Building R5 Modification 3

Design Amendments
State Significant Development Modification Assessment
(SSD 6966 MOD 3)

April 2022

Published by the NSW Department of Planning and Environment

Figure 3 | Approved roofscape (left) and proposed (right) roofscape with removed lift motor room and relocation of building maintenance unit (Source: Applicant's Design Report and Architectural Plans)

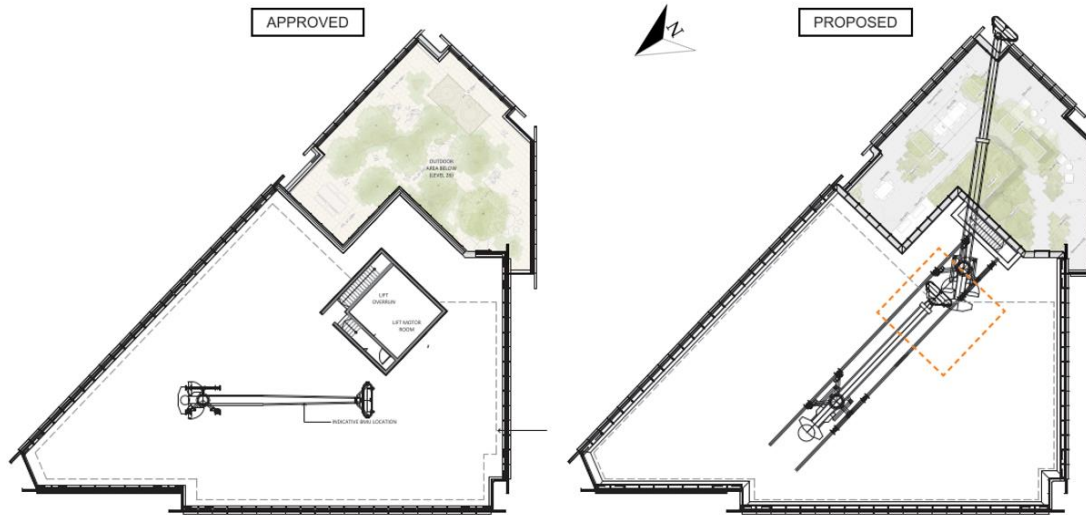
- The proposal seeks approval to remove the lift motor room (LMR) and to relocate the building maintenance unit (BMU) on the rooftop of Building R5.
- The Applicant provided a Vertical Transport Letter which concludes removal of the lift motor room does not impact on lift performance, which remains commensurate with international global standards.
- The Department considers the proposed roof changes are acceptable as:
 - the removal of the LMR will reduce the visual impact of rooftop plant, without compromising lift performance
 - the relocation of the BMU to the former LMR location allows more efficient maintenance of building facades.

The Department recommends condition A2 is amended to reflect the revised plans.

Figure 4 | Approved (left) and proposed (right) ground floor with new retail lift lobby, three new entry/exit doors to retail areas, minor changes to internal separating walls (Source: Applicant response)

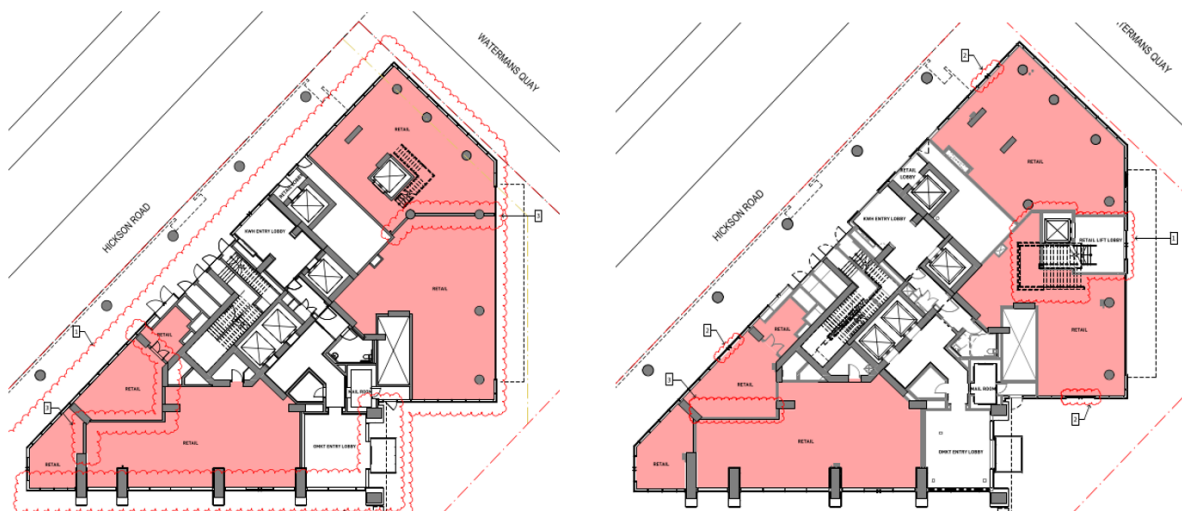
Ground floor and retail entry	• The proposal seeks to add a new retail entry and lift lobby from Watermans Quay and add three new access points to ground floor retail tenancies. • The Department considers the ground floor and retail entry changes are acceptable as: • the additional access points will provide more permeability to and activation of the surrounding area • the lift lobby design is well integrated into the facade and of similar proportions to the approved entry	The Department recommends condition A2 is amended to reflect the revised plans.
